**SUBJECT: LOWER CURTAIN ASSEMBLY – ALL CIM
Part # 9051823-01**

**Number: 2020-01.1
Product: CIM Cubers
Date Issued: JAN 2020
Date Updated: May 2021
From: Technical Services**

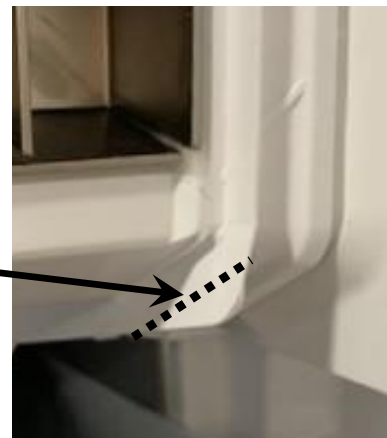
Updated Lower Curtain Assembly to aid in water redirection on the bottom of the Evaporator. On any CIM Cuber with broken tabs on the Water Return at the bottom of the Evaporator, installing the new Curtain will assist in water being directed back into the Water Sump.

← Extended rib (inside the outer rib) on Curtain directs water into the Sump.

**NOTE: DON'T TRIM TABS FLUSH
TO BOTTOM OF EVAPORATOR**

Trim remaining tabs about 3/16" to 1/4" from bottom of Evaporator(s)

If tab(s) have broken flush, apply a bead of NSF food grade silicone along previous location of tab.
